Appendix G

Dallas LFMP Ticketing Hall Simulation

To: Dan Weber, Diego Rincon, Terry Mitchell, Kenneth Gwyn, Cliff York, Wade Ellison
From: Karen Kavanagh
CC: Johnny McKnight, Jamey Tasker, Marty Tasker, Manoj Patel
Date: 5/25/2015
Re: Reduction in Ticket Hall Size - Simulation Results

2.1 Original Three Pod Design

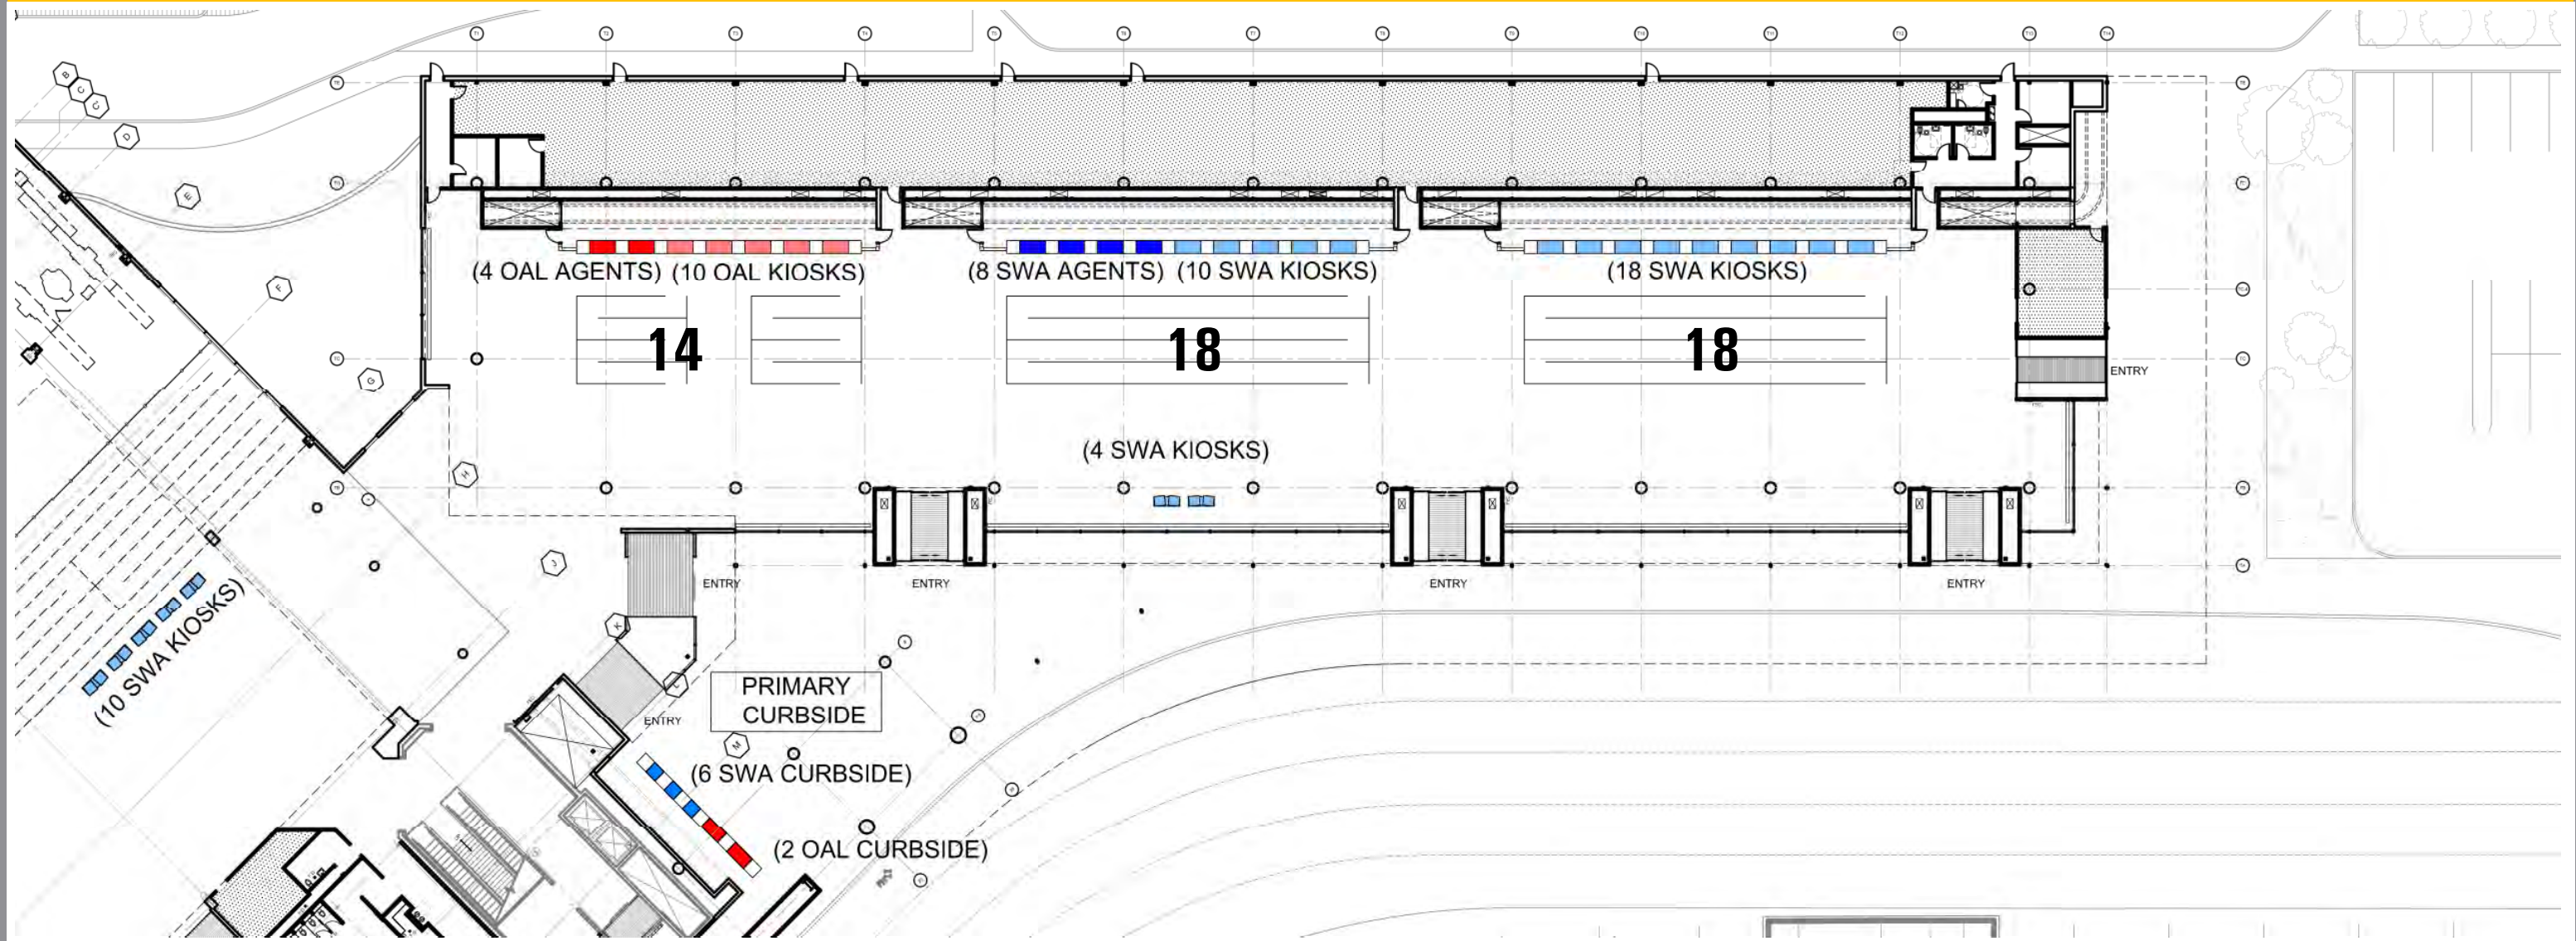
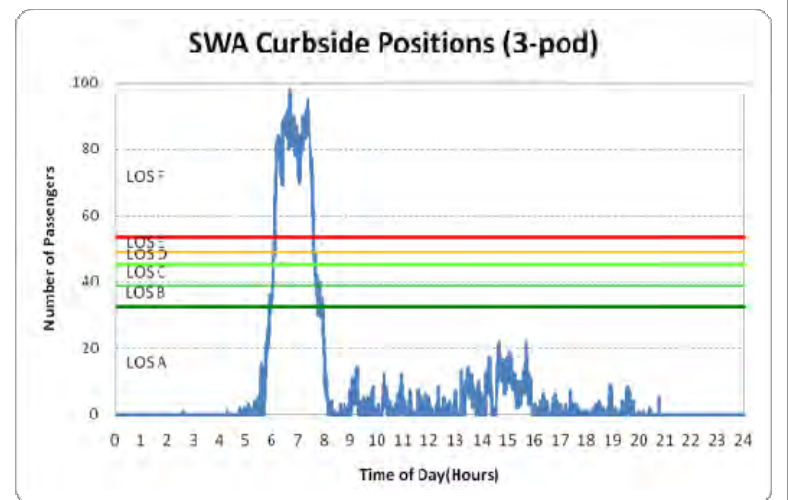
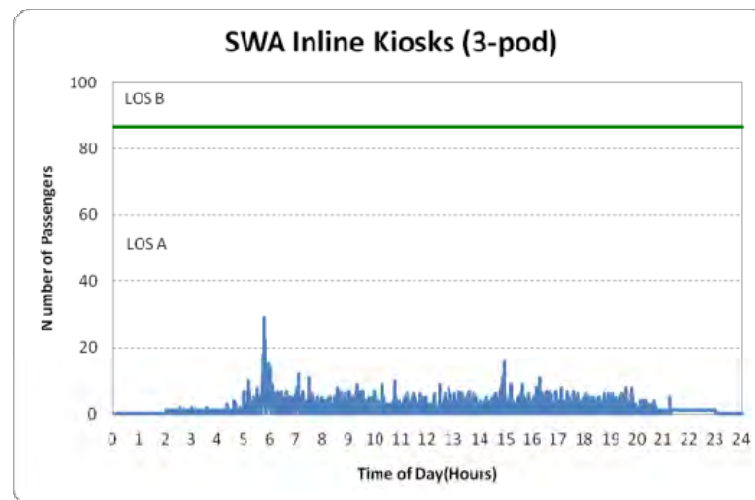
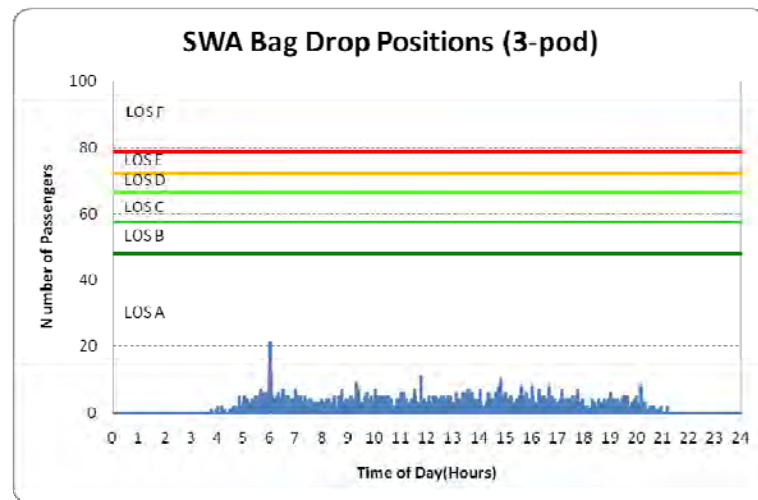
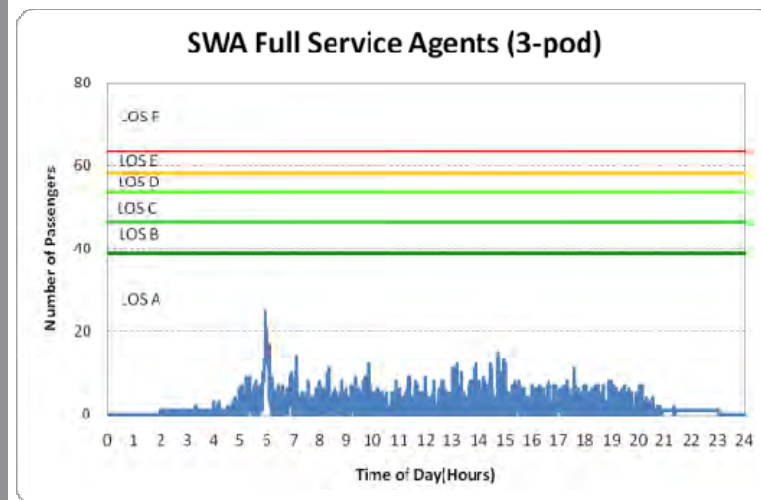
1. Original design based upon TARPS metrics and touch point requirements
2. Not seen as reflective of current industry trends

1. Achieves LOS A at all times in all areas
2. Excellent level of performance based upon numbers of touch points at the belt

3.2 Two Pod (VE Idea)

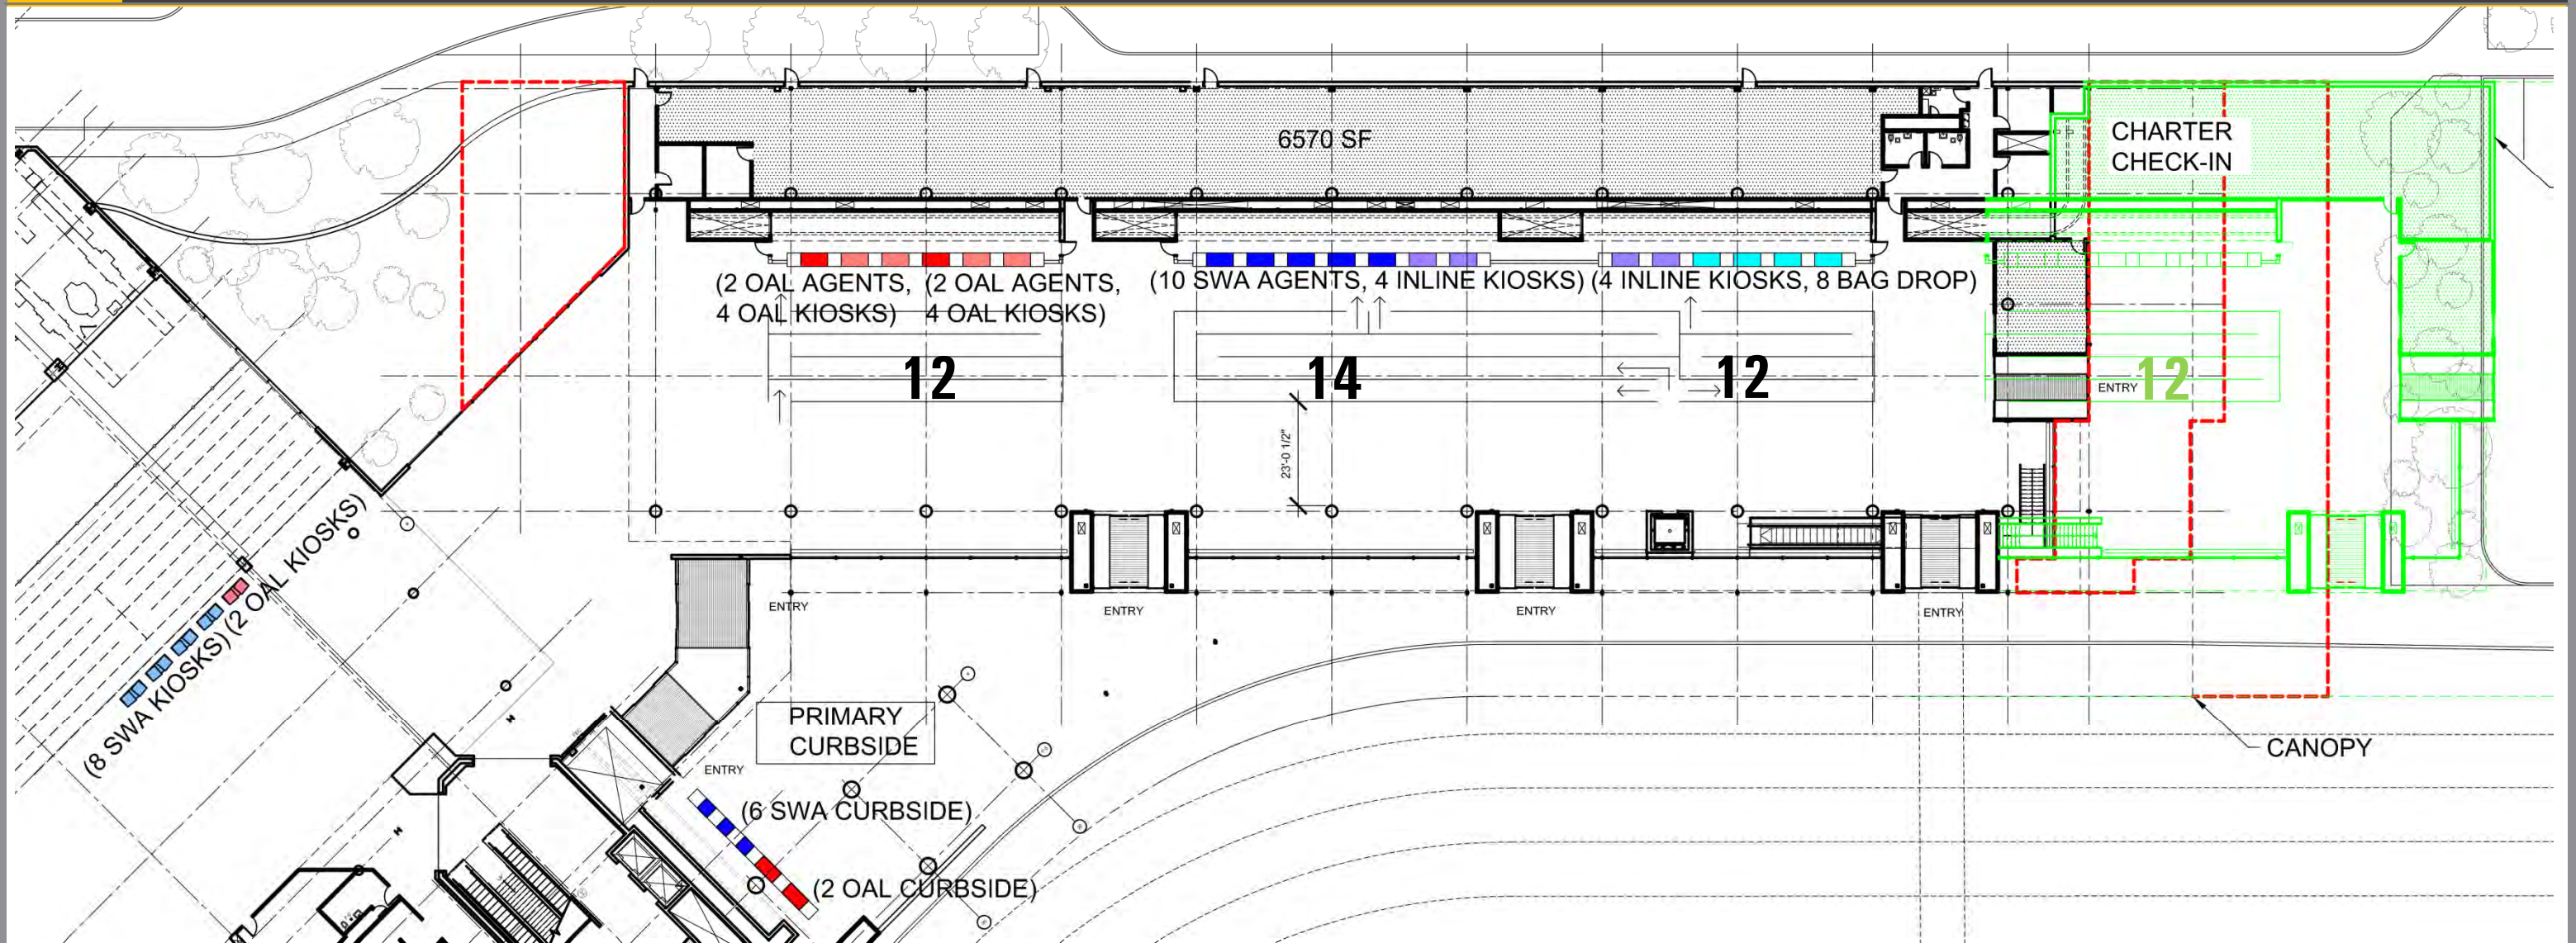
The VE idea that reduced the Ticket Hall size by one-third in order to save \$3.5 M resulted in LOS F and was determined to not be feasible. At the request of SWA, Corgan subsequently developed a modified design for the Ticket Hall which included a 15% reduction in overall size, while maintaining three ticketing pods and meeting other TARPS metrics. TransSolutions ran the simulation for this design to determine the Level of Service (LOS) that would be achieved with this option.

4.1 Modified Three Pod

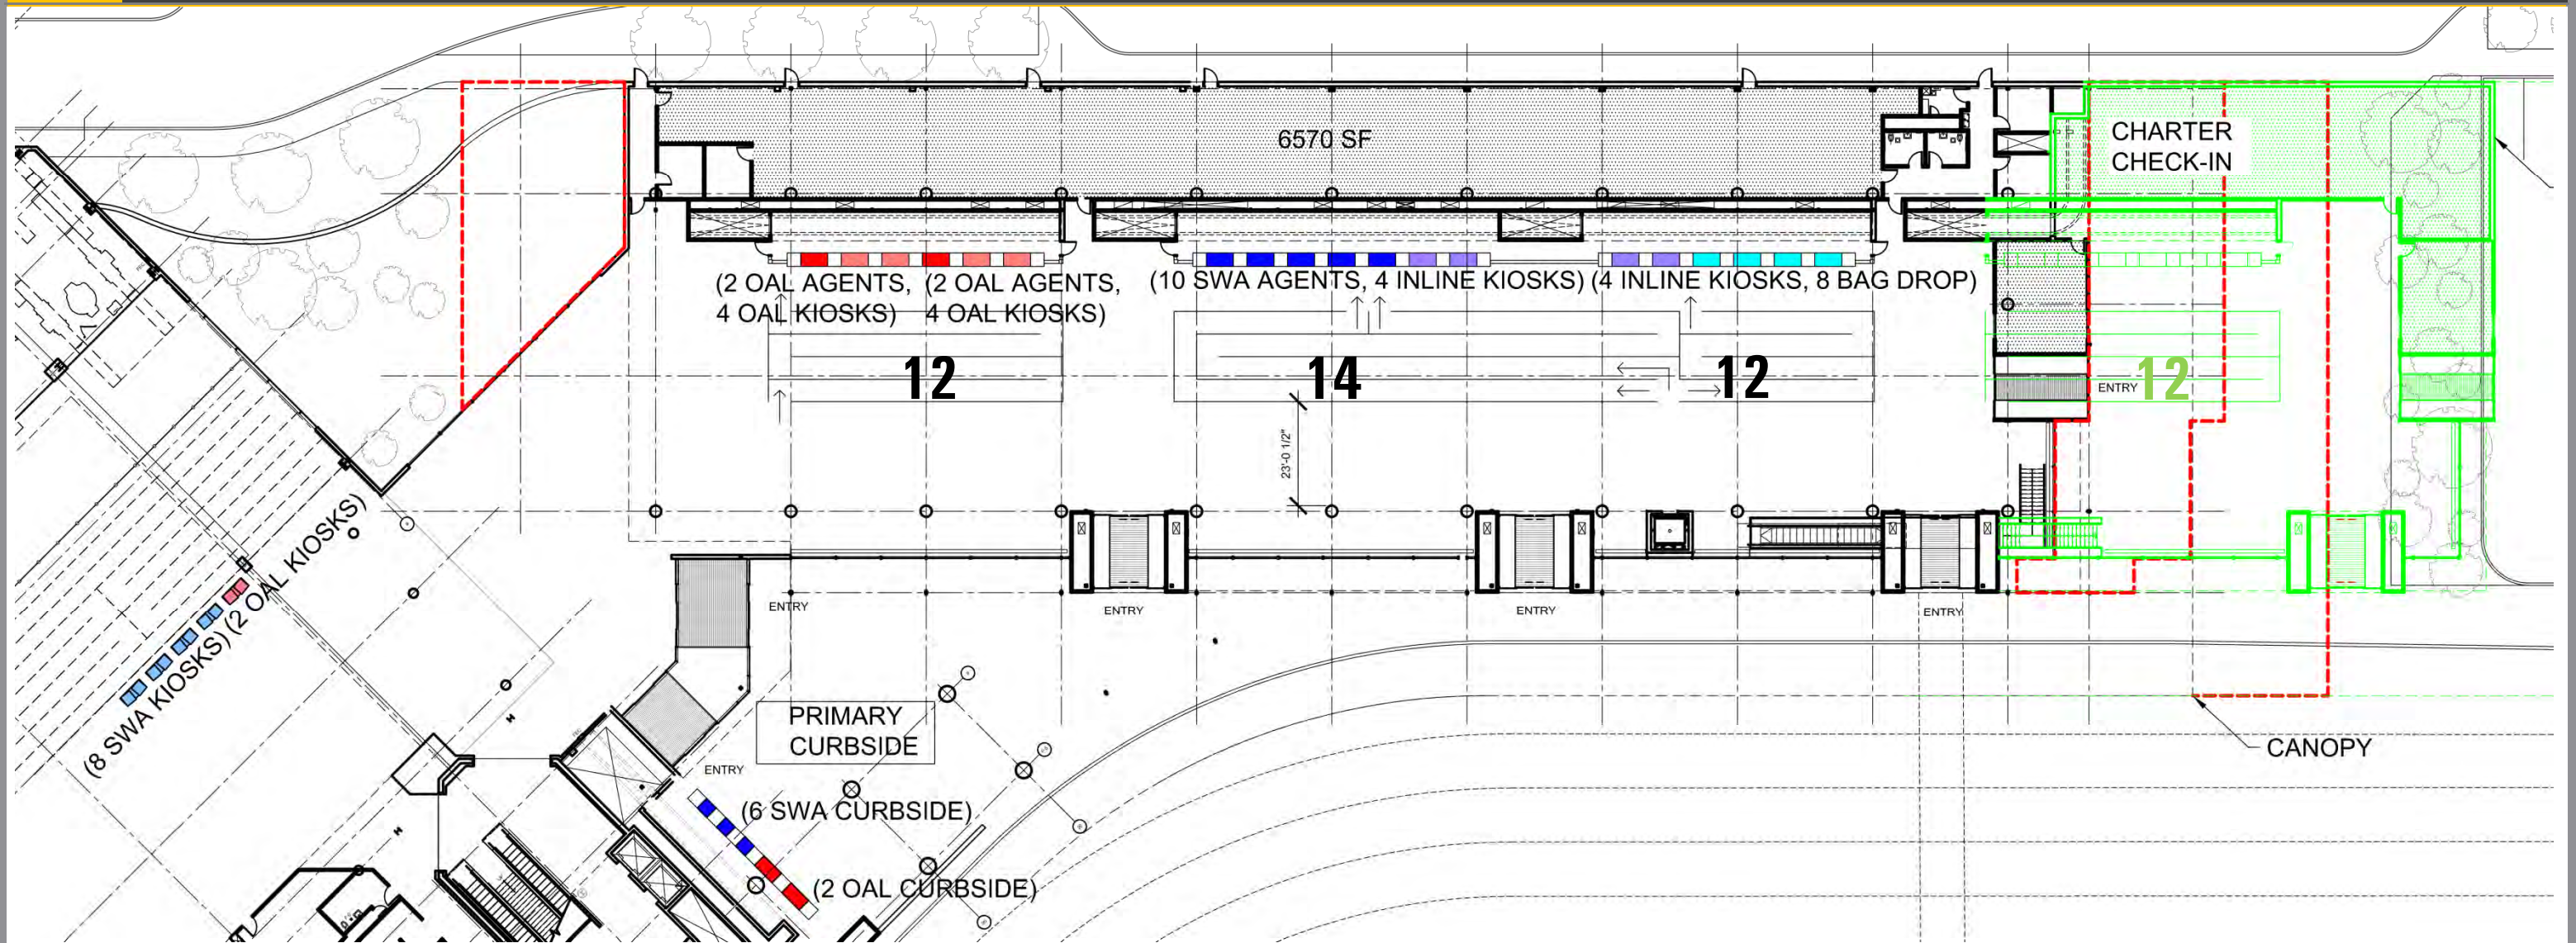
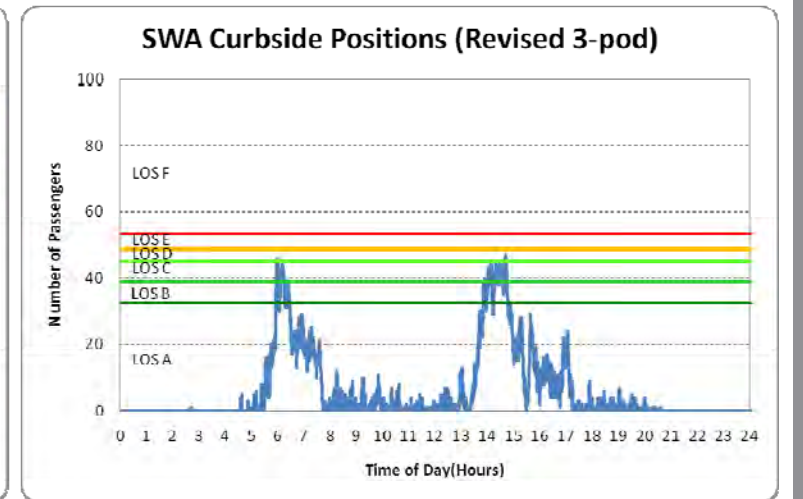
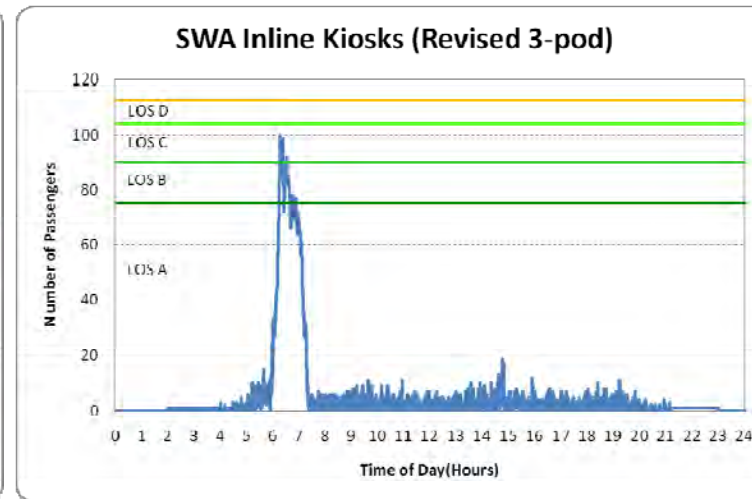
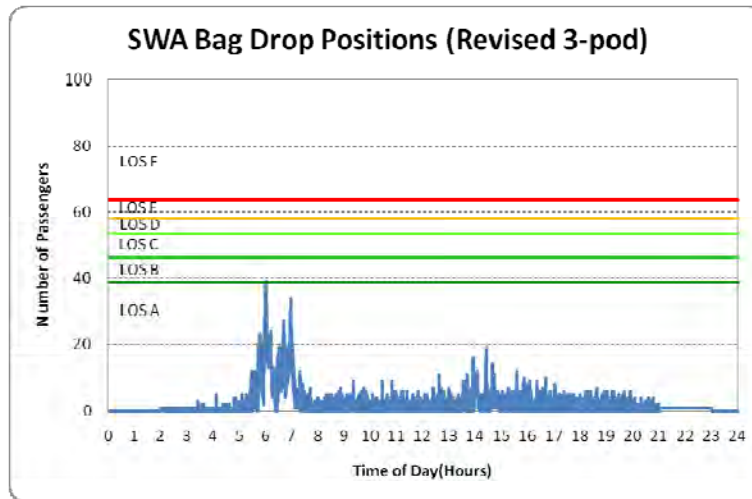
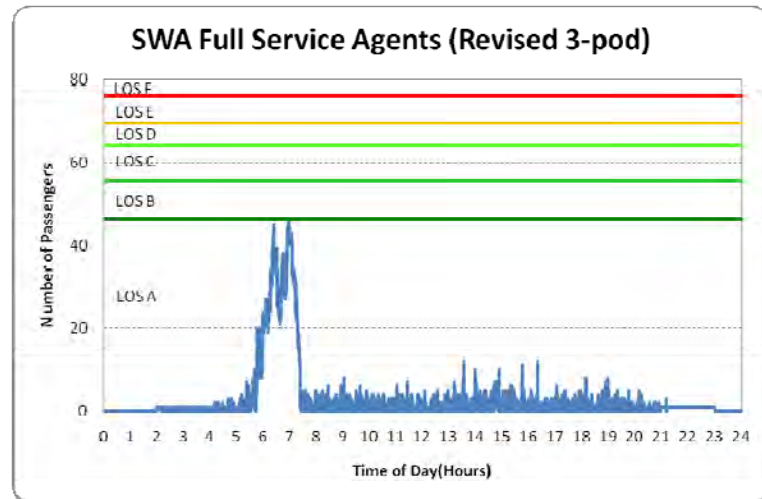
1. Uses modified Full Service and Kiosk processing times provided by SWA, maintains 3 takeaway belts
2. Reduces hall by approximately 15% in size and \$2M in cost
3. Provides for future 4th pod to be added without additional BHS cost or basement construction
4. Minimal reduction in effective curb length with no measurable impact to roadway LOS
5. The location of an additional 16 boarding pass only kiosks is TBD

1. Performs at LOS A with 80% load factor
2. Opening day build-out allows for growth to 85% load factor without reducing LOS past C

1. We recommend adopting the Modified 3 Pod layout as shown on page 4.1
 - a. This layout accommodates the opening day and ultimate flight schedule activity levels at or below LOS C at TARPS load factors
 - b. This concept allows for future expansion of one additional pod (12 positions) with minimal BHS and basement work required
2. We recommend maintaining the East Tunnel access directly into the ticketing hall
